FILE: SERVICE: GROUP 00 OF SERVICE INFORMATION BINDER  
PARTS: GROUP I OF INFORMATION – PARTS & ACCESSORIES BINDER

Campaign No. 2010110008, January 2011

SUBJECT: **Model 463, Model Years 2002 - 2010**  
**Remove Headlamp Grill, Replace Front Turn Signal Lenses**

Figure 1

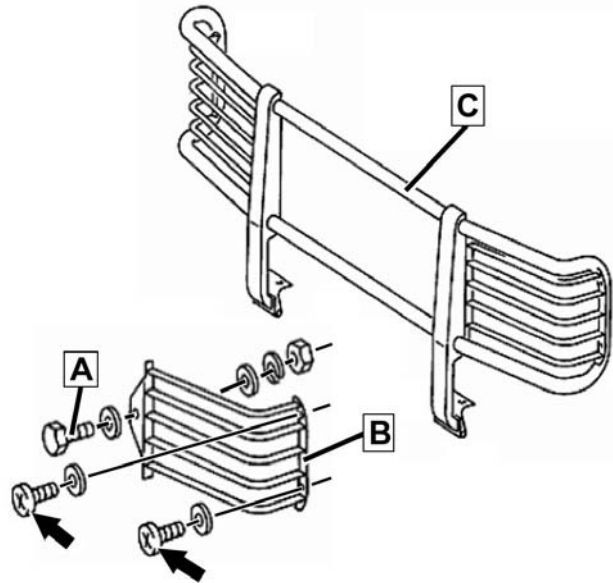
### 2. Remove headlamp grill (B, Figure 1):

- Remove bolt (A) and two screws (arrows) then remove headlamp grill (B) from front brush guard (C). Repeat this step on opposite side.
- Clean area of brush guard where headlamp grills (B) were installed.

- Brush guards must **not** be installed again
- All parts removed in this step **must** be returned to the QEC.
- Cost of parts removed in this step must be reimbursed to customer. Refer to parts reimbursement table on page 4.
- Cost of aftermarket (non Mercedes-Benz genuine) parts removed in this step must **not** be reimbursed to customer.

**Figure 2**

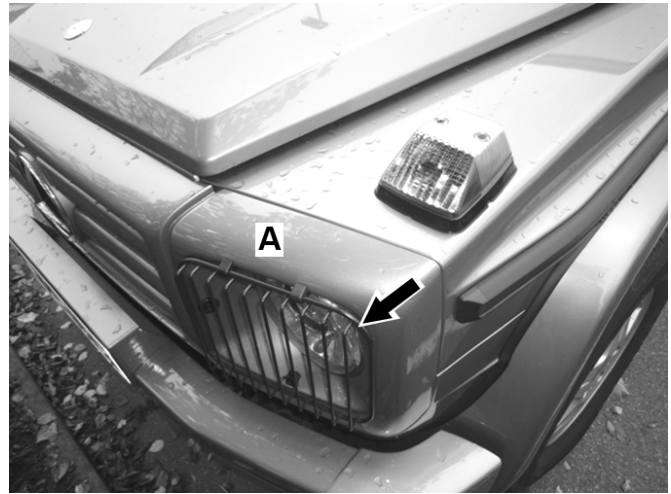
3. Replace headlamp trim (A, Figure 2):

- Remove headlamp trim (A) with head lamp grill (arrow); refer to WIS: AR88.00-P-2100G.

- If equipped with brush guard, lower brush guard to access headlamp trim (refer to Practical Hints chapter in Operator's Manual).
- For models with headlamp washers: Transfer washer nozzles from old headlamp trim (A) to new headlamp trim (A).
- Be careful not to scratch paint when removing and installing headlamp trim (A).
- Install new trim (A) (without grill mounting holes) painted in same color as vehicle.

**Figure 3**

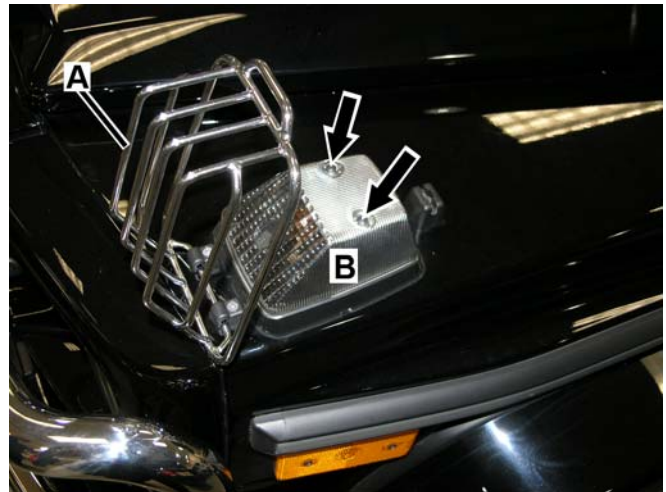
4. Replace front turn signal lenses (B, Figure 3):

- Open directional grill (A).
- Remove 2 screws (arrows) then remove lens (B).
- Install new lens (B) in reverse order.

Use only **hand tools** to tighten screws (arrows), do **not** over-tighten screws (arrows).

**Affected Headlamp Grills and Turn Signal Grills**

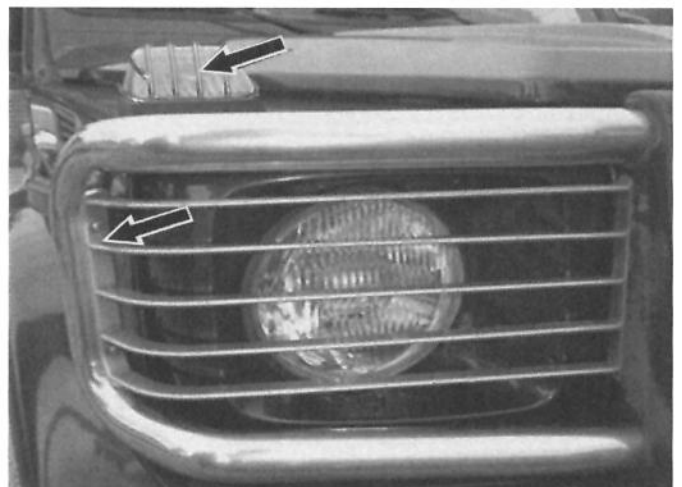
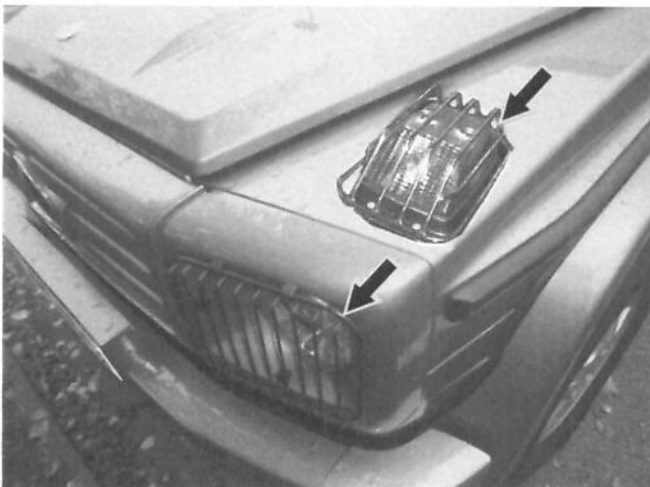
The headlamps of the affected vehicles are equipped with a protective grill for protection of the headlamps during off-highway operation. FMVSS 108 S7.8.5 specifies that a grill shall not be installed in front of the lamp. The affected vehicles with the protective grills installed fail to meet all luminosity requirements of FMVSS 108 thereby increasing the risk of a crash. The affected vehicles may also be equipped with an allowable grill cover for front turn signal protection which also affects compliance with FMVSS 108 by reducing the turn signals' light visibility to other motorists.

MBUSA will conduct a recall campaign for the subject vehicles described above. The recall will be conducted to remove the headlamp grills and install improved turn signal units optimized for usage with front fender mounted grills (if installed). MBUSA will reimburse you for the cost of the removed headlamp grills.

**Affected Headlamp Grills and Turn Signal Grills**

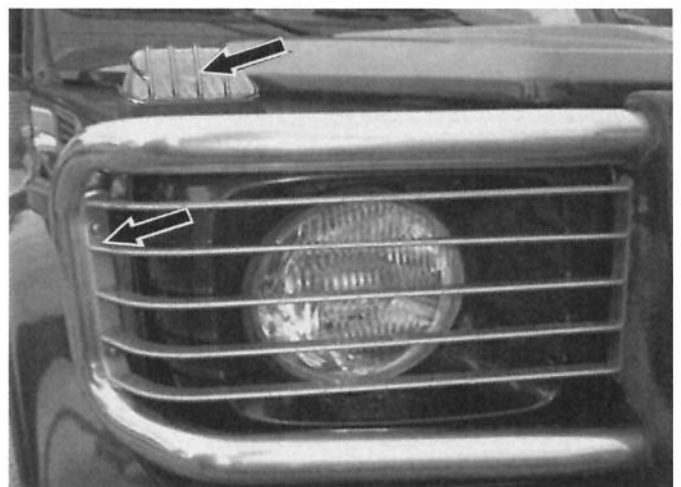
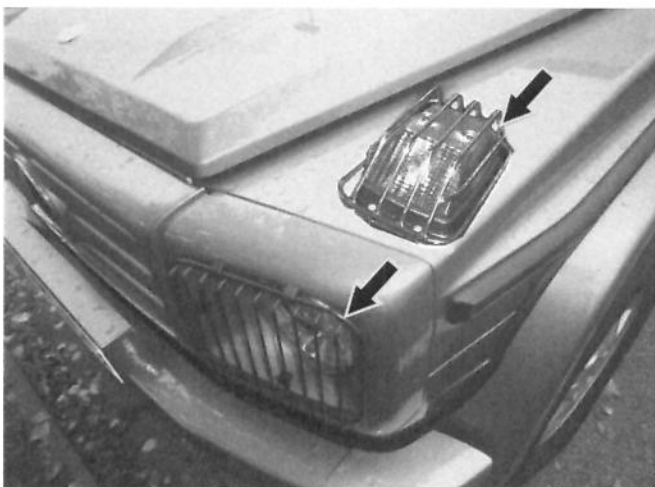
The headlamps of the affected vehicles are equipped with a protective grill for protection of the headlamps during off-highway operation. FMVSS 108 S7.8.5 specifies that a grill shall not be installed in front of the lamp. The affected vehicles with the protective grills installed fail to meet all luminosity requirements of FMVSS 108 thereby increasing the risk of a crash. The affected vehicles may also be equipped with an allowable grill cover for front turn signal protection which also affects compliance with FMVSS 108 by reducing the turn signals' light visibility to other motorists.

**If your vehicle is equipped with a Mercedes-Benz accessory headlamp grill or front fender mounted turn signal grill (see reverse side for photo) please contact us at 1-(800) FOR-MERCEdes (1-800-367-6372) to be added to the recall campaign.**

MBUSA will conduct a recall campaign for the subject vehicles described above. The recall will be conducted to remove the headlamp grills and install improved turn signal units optimized for usage with front fender mounted grills (if installed). MBUSA will reimburse you for the cost of the removed headlamp grills.
